KAPITI COAST
DISTRICT COUNCIL

Addition to plan BC 100497

Storage loft in bay 4 of 4 Bay Shed

Addition to plan: storage loft
in Bay 4 - 4 Bay Shed

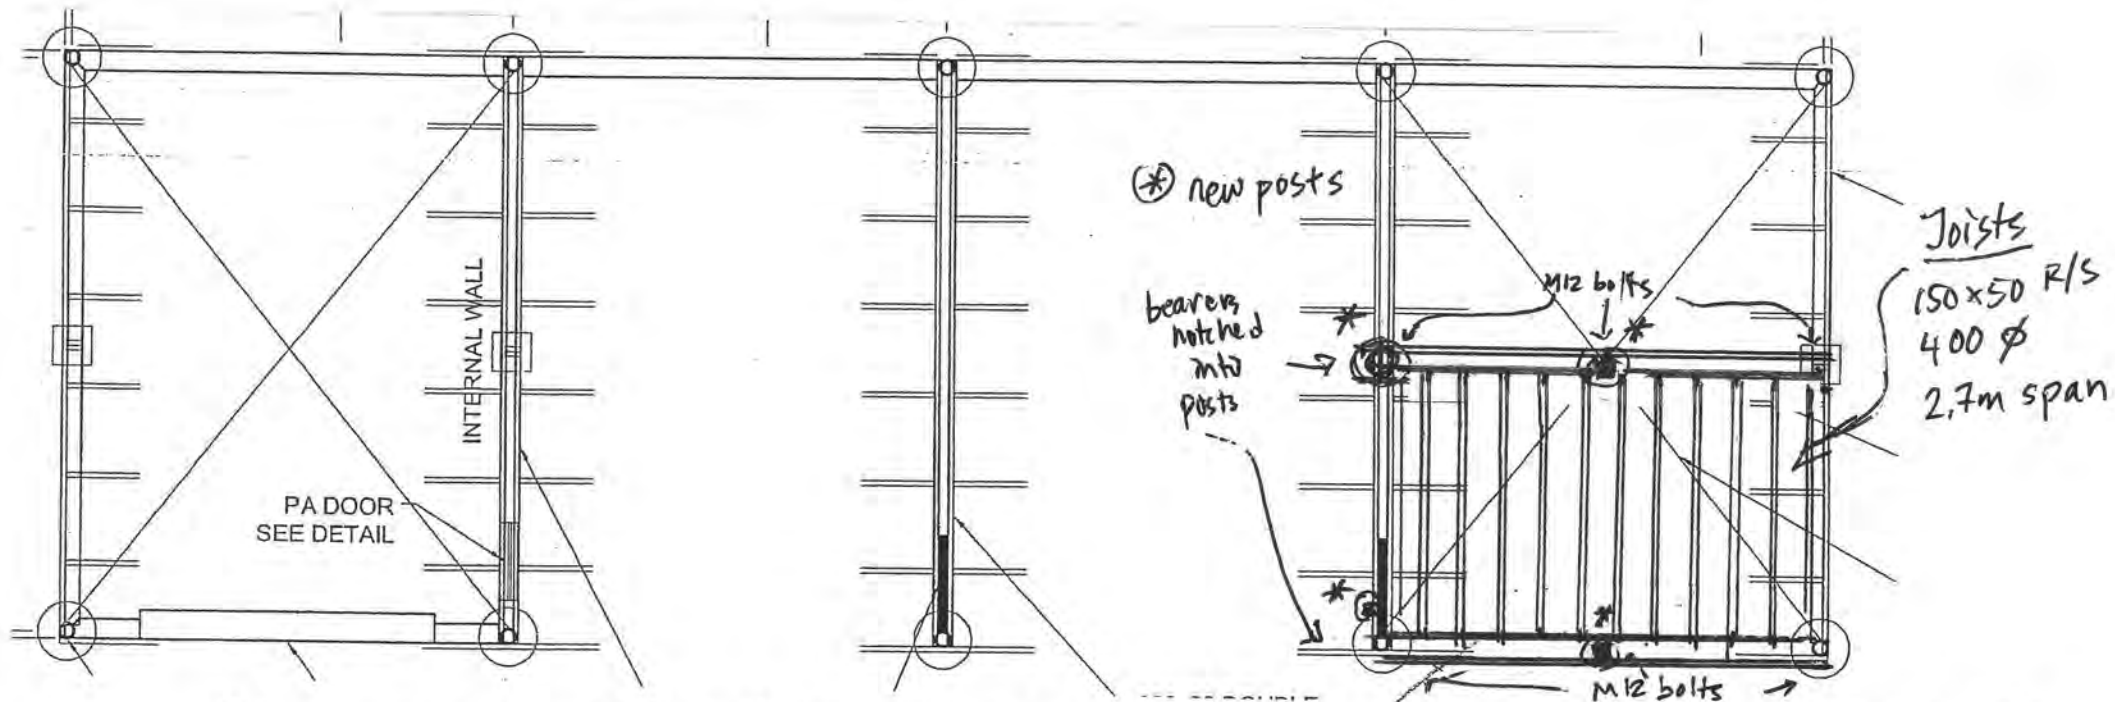
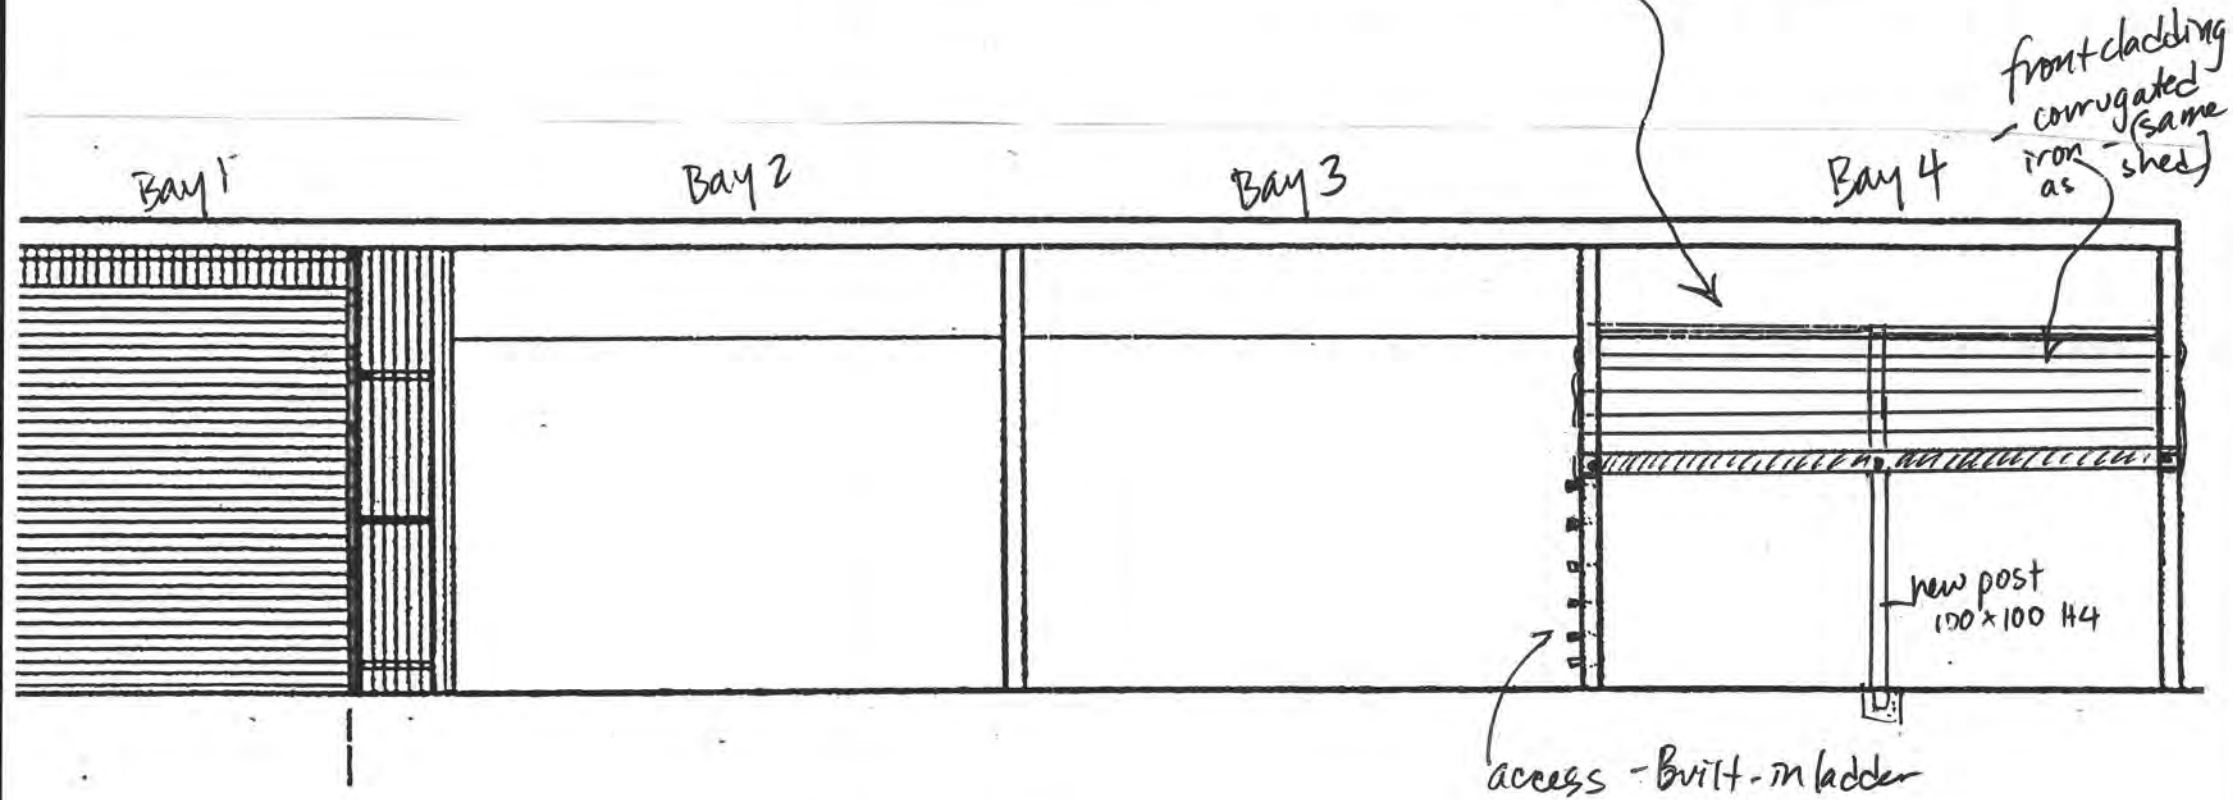
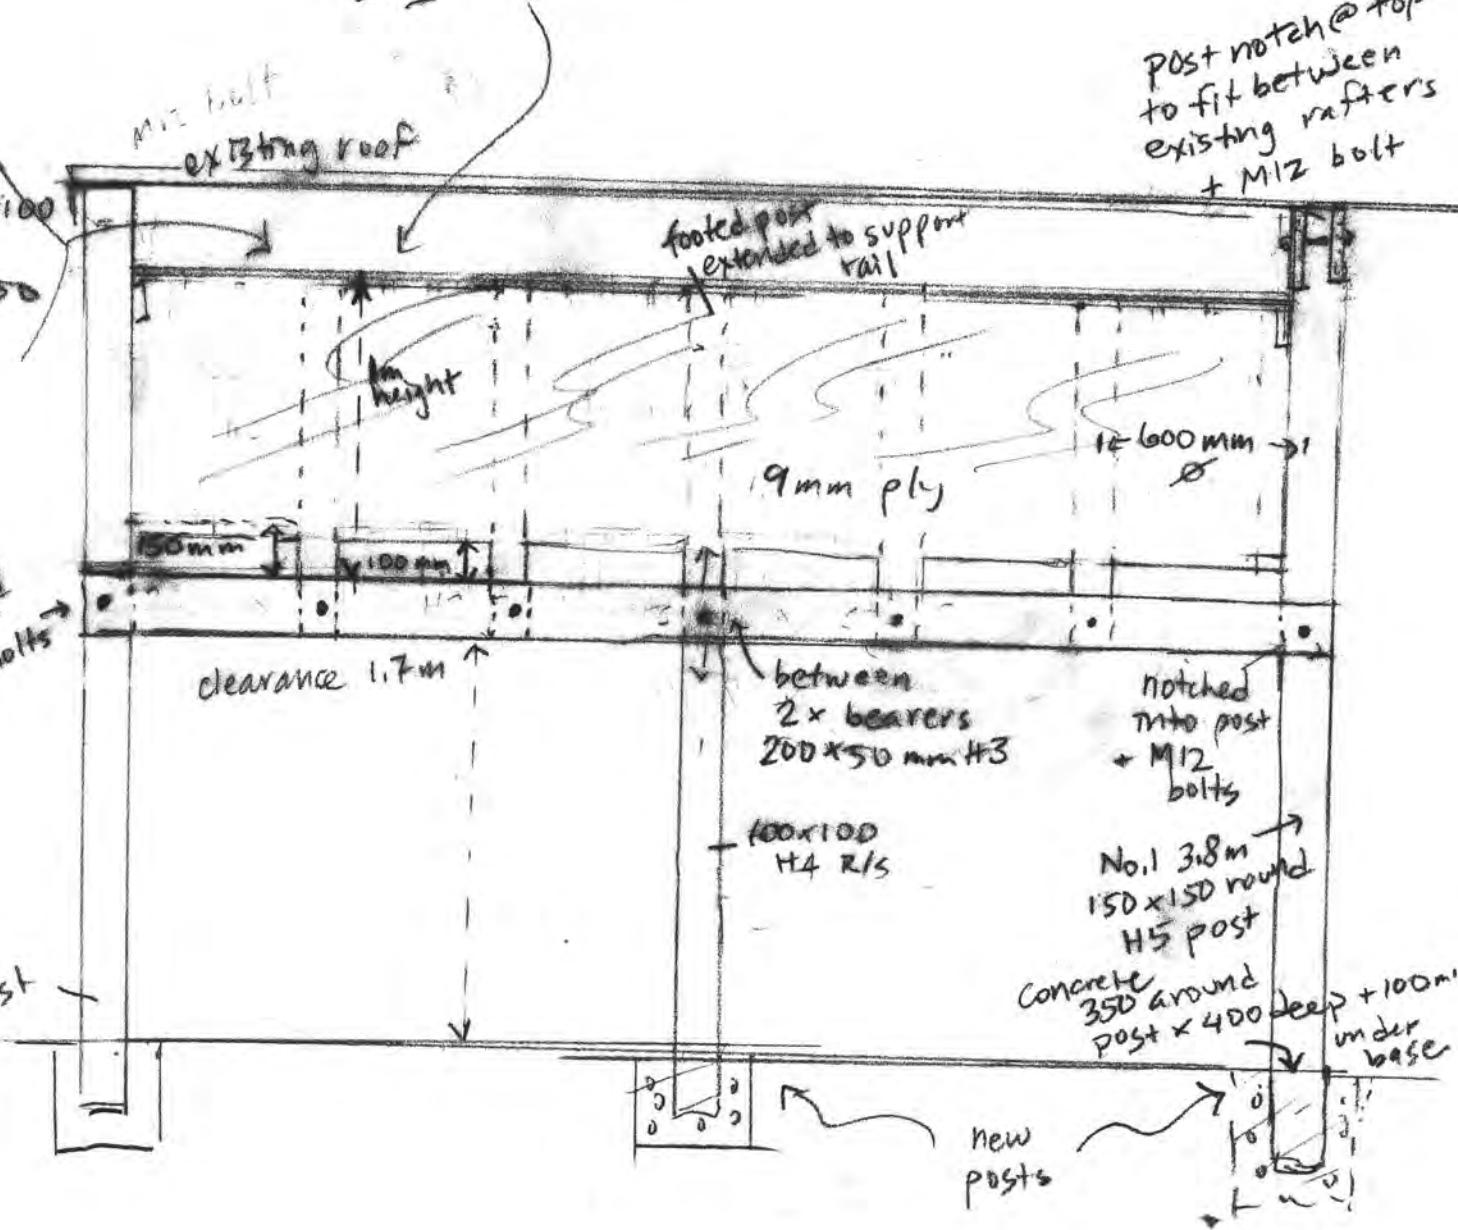
- 2) The existing consented plans indicate a 150x50 girt that the bearer will attach to, this is outside the scope of NZS 3604.
- 3) 100x100 piles outside the scope of NZS 3604 also.
- 4) Please clarify the notch depth for the bearer to the post attachment.
- 5) Clarify the stress grade of the joists MSG8 or higher is acceptable with the current design.
- 6) As the structure is specifically designed (by an engineer) then confirmation should be sort that notching of the structural posts is acceptable and written evidence provided. I recommend contacting the manufacturer.

- * Mark bracing lines on the plan & all member sizes ~~and~~ ensure the plan matches the calculations.
- * Existing consented plans show a 150x50 gird support for bearer attachment - insufficient to act as a pile.
- * 114 100x100 piles outside of 3602 & 3604 -
- * Clarify ~~bearing~~ notching & depth of bearer to post.
- * Clarify stress grade of joists - MSG8 or higher is ok.
- * Existing ^{structural} posts that are notched - should be checked by an engineer/Goldpine.

6/5/11 * Storage left removed from the plans - per email from Derrin.
* Met Paul Goodall at the Council - he explained that the sheet that was provided by the applicant was an as built provided to him by the builder he had reviewed it and had to add more bracing. So that pg should not have been provided to us. Calculations checked above.
